Addendum #3

Invitation to Tender 2021-11

Daycare project at School ÉEC Sainte-Croix, Tiny

Architectural Addendum No. 1

A1-3-1

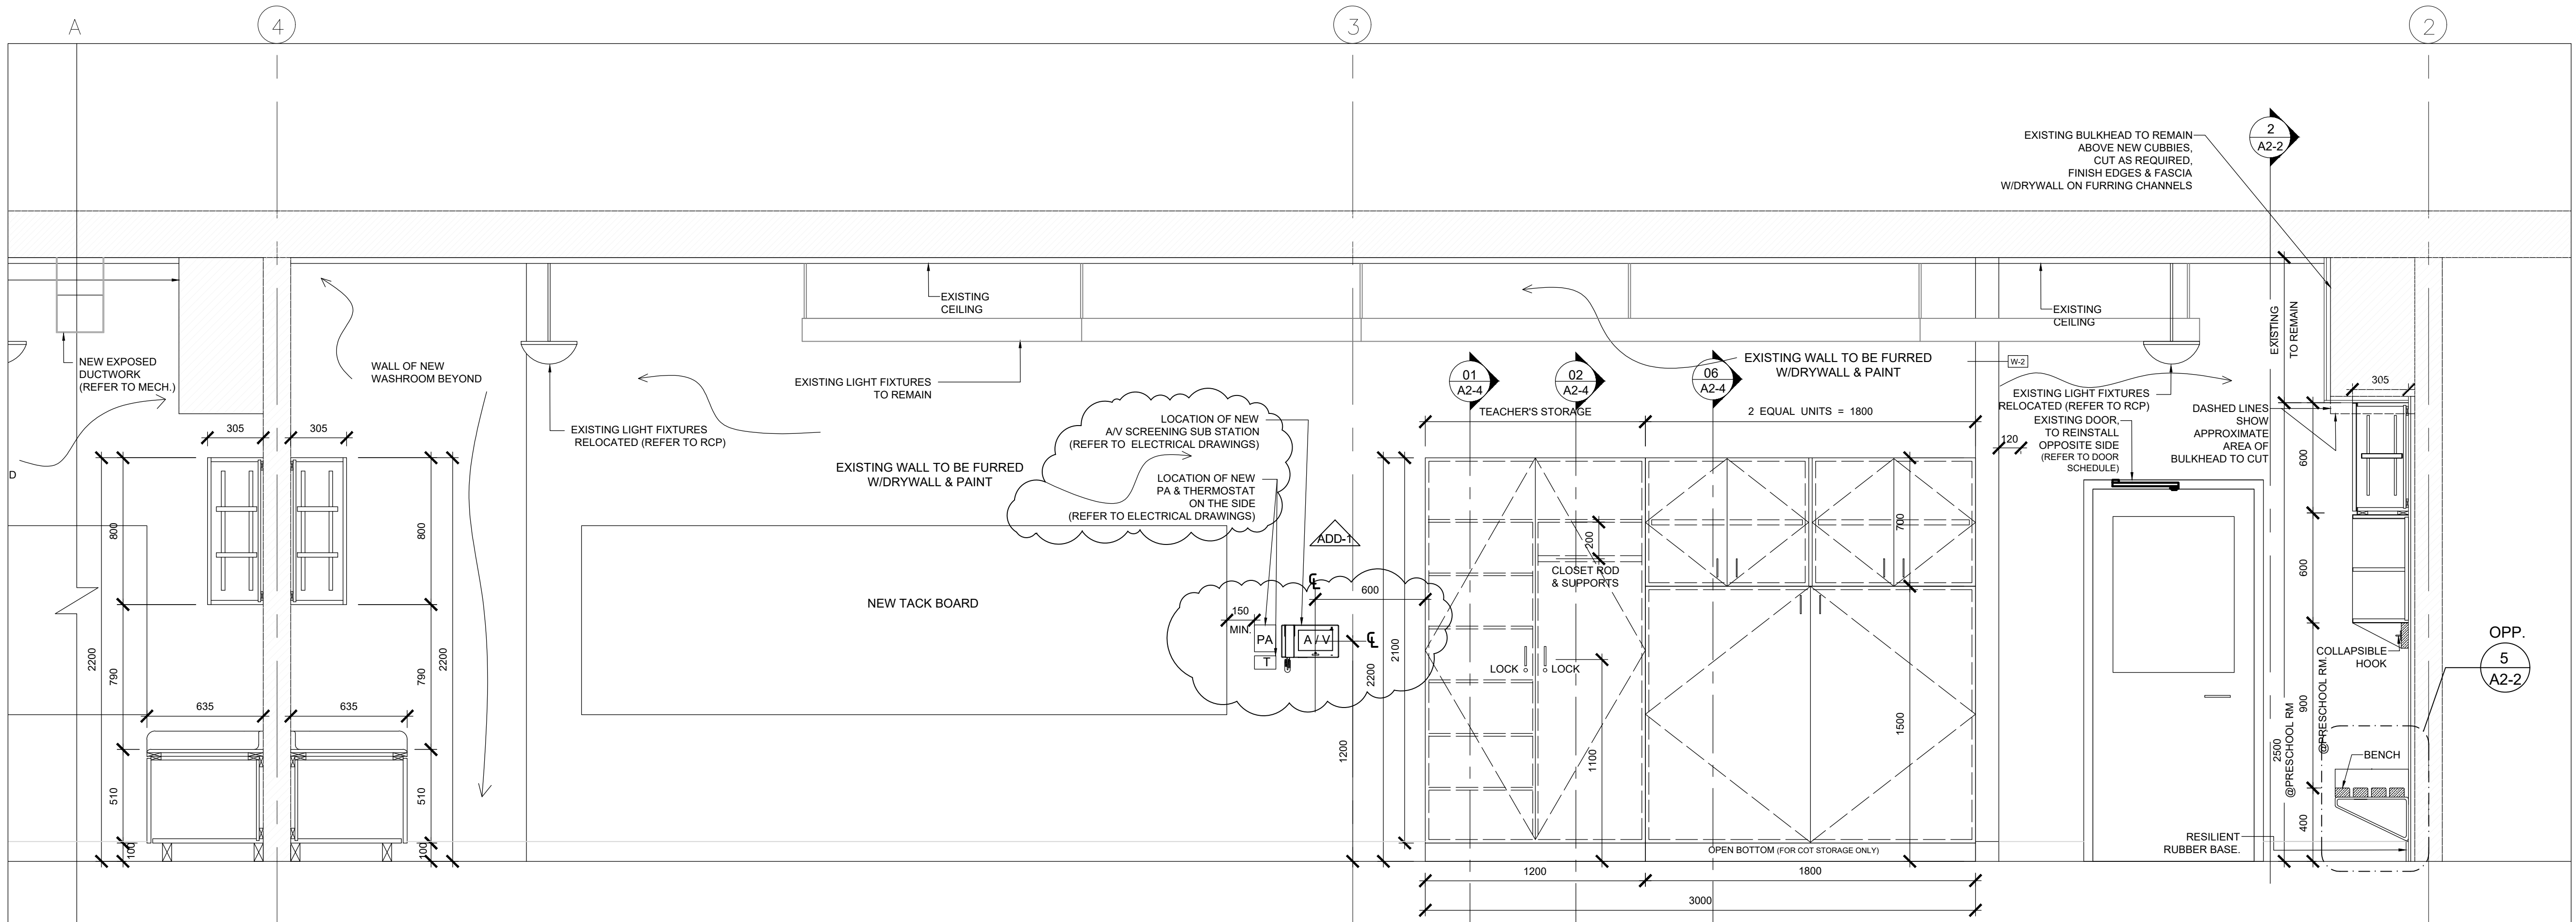
- 1- Drawing 1/A1-2-1: Revisions to include the clearances required for New door D1. Existing dimension affected to be verified by GC.
- 2- Drawing 1/A1-3-1: Revisions showing door clearances required for New door D1 and location of new PA device, Thermostat and A/V screening devices.
- 3- Drawings 1&2/A2-1: Revisions showing location of new PA device, Thermostat and A/V screening devices.
- 4- Drawing 5/A2-3: Showing ceramic tiles while the washroom partition deleted.

DATE	22 MAY 2018	PLOTTED DATE	22 MAY 2018
CHECKED	M. SPENCER	DRAWN	GDA
PROJECT NUMBER	18-047	DRAWING NUMBER	S1

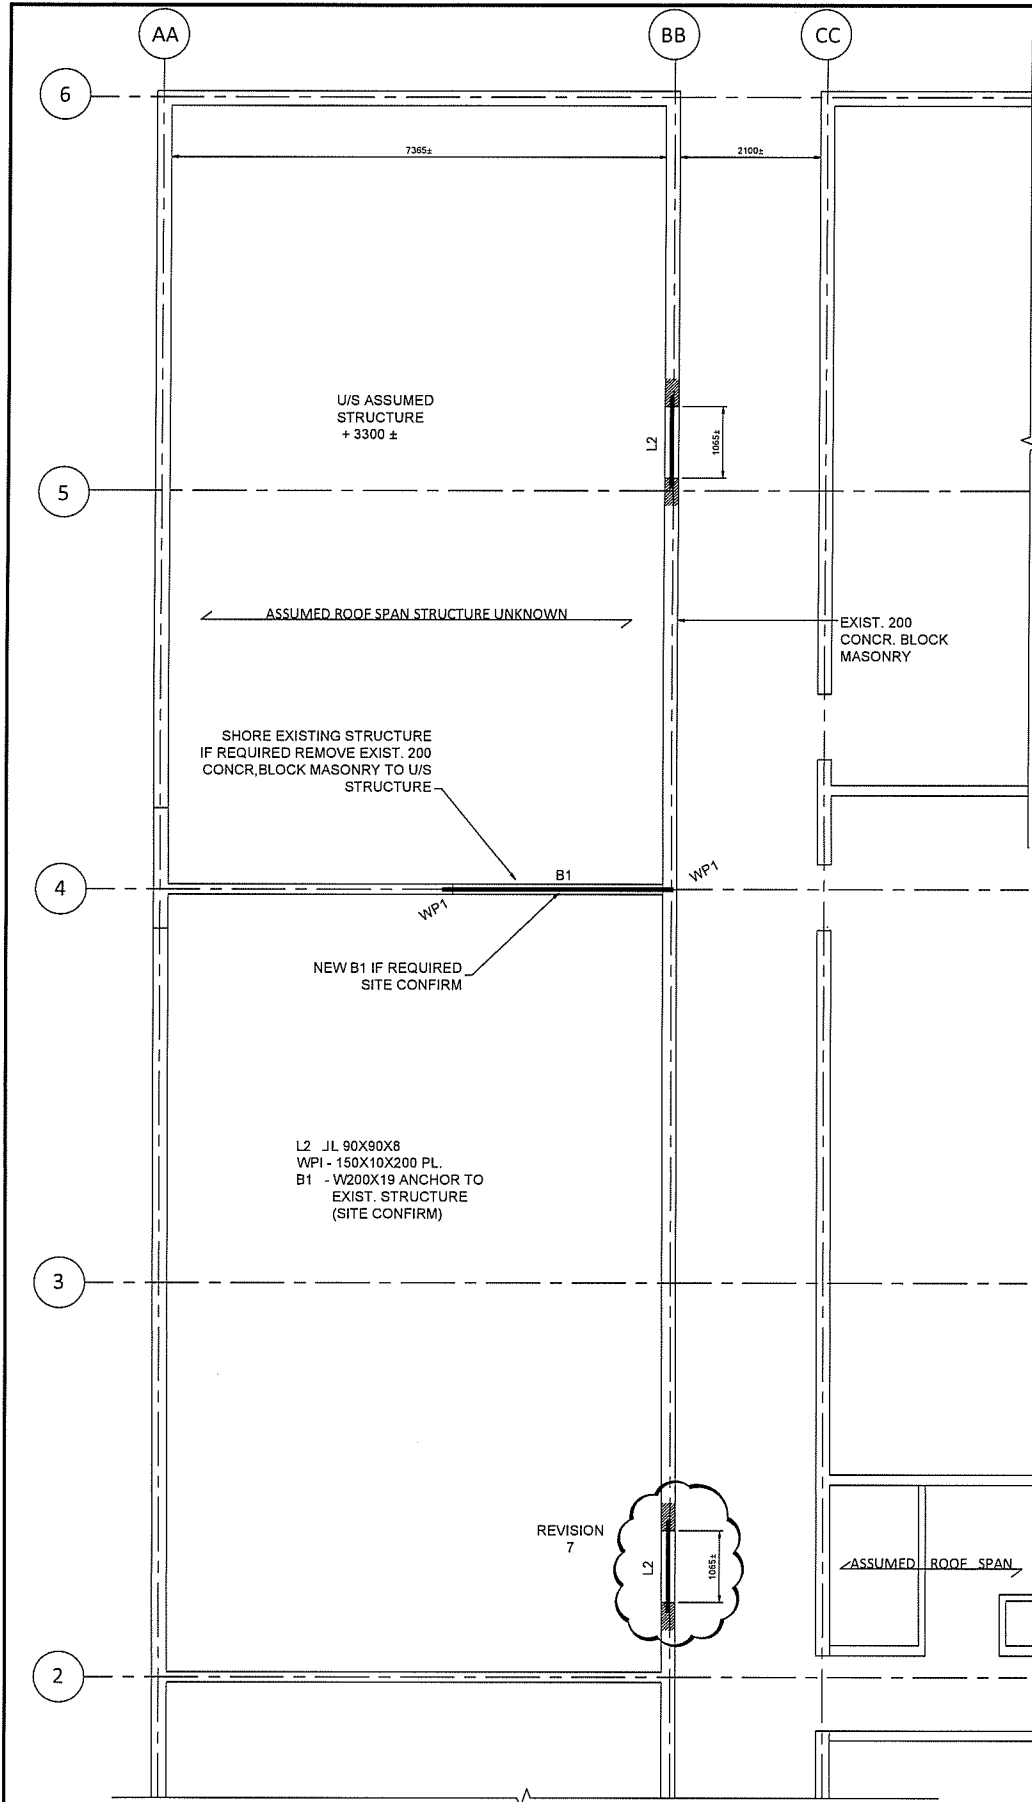
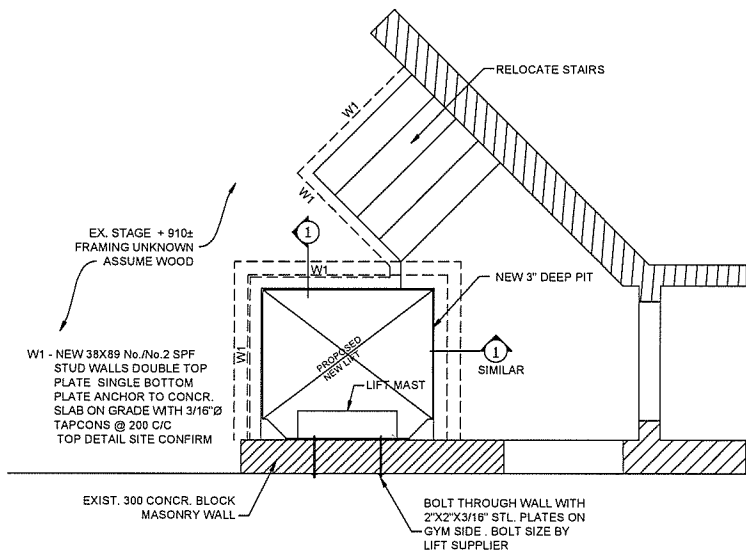
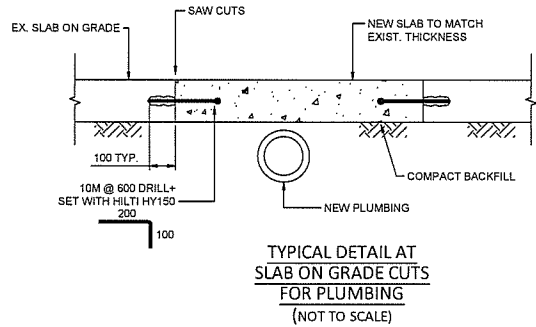
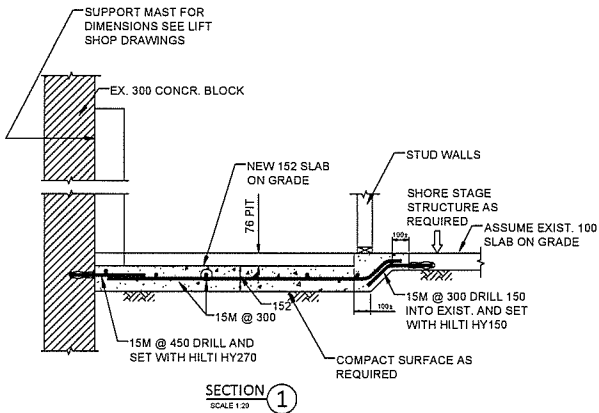
- 1.0 Provide new steel lintel L2 over enlarged doorway to classroom 120 as shown on attached revised drawing S1

M2.0D-A-1

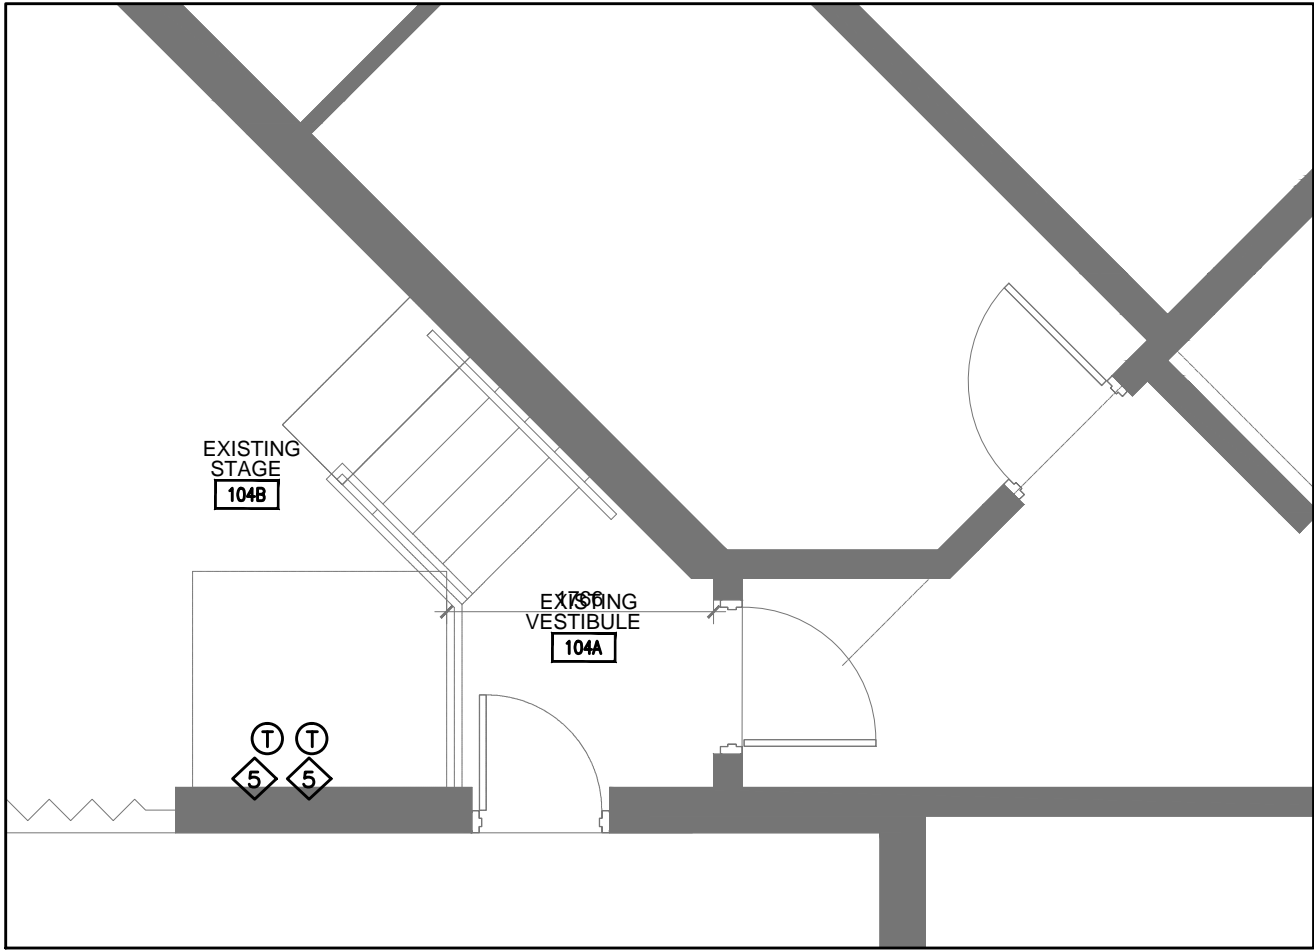
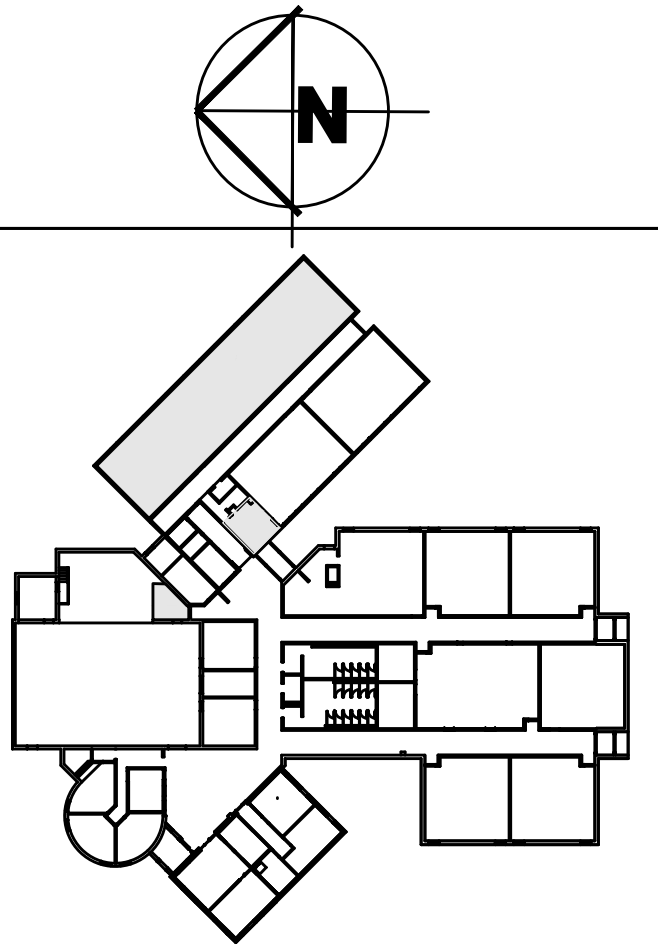
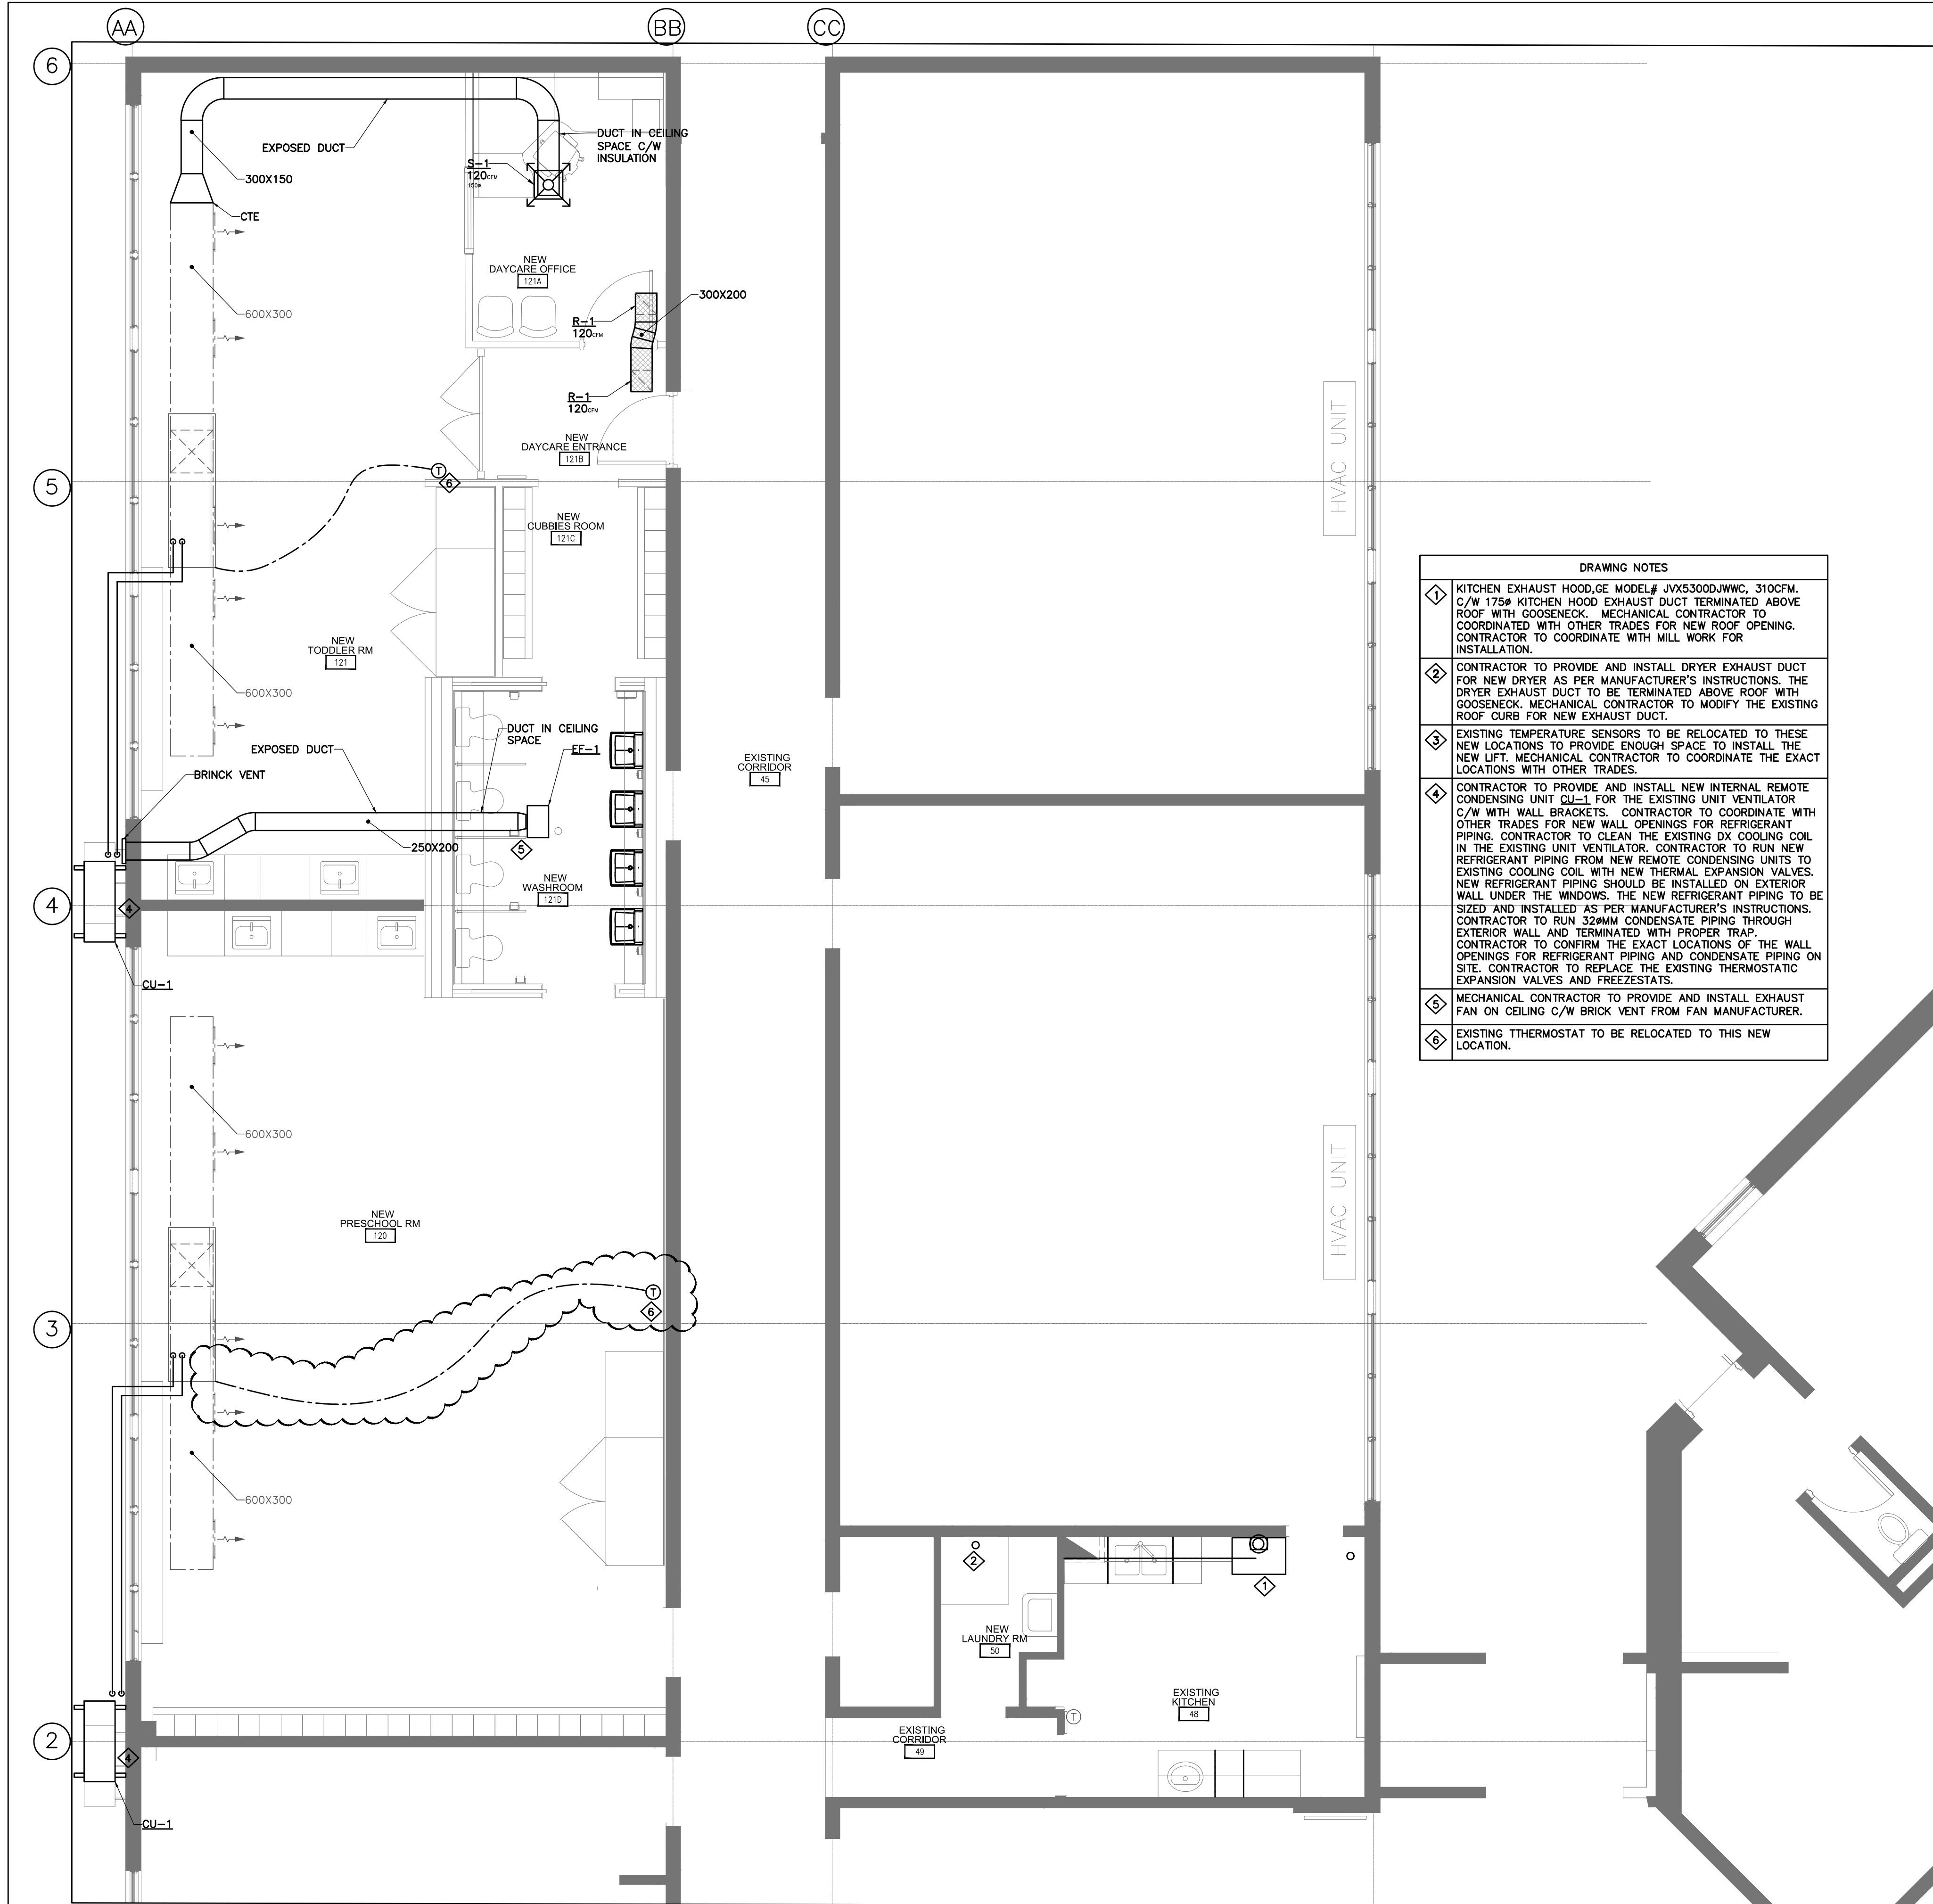
Refer to attached mechanical sketches M2.0D-A-1 & M3.0-A-1, location of the thermostat revised as shown in the mechanical sketches.
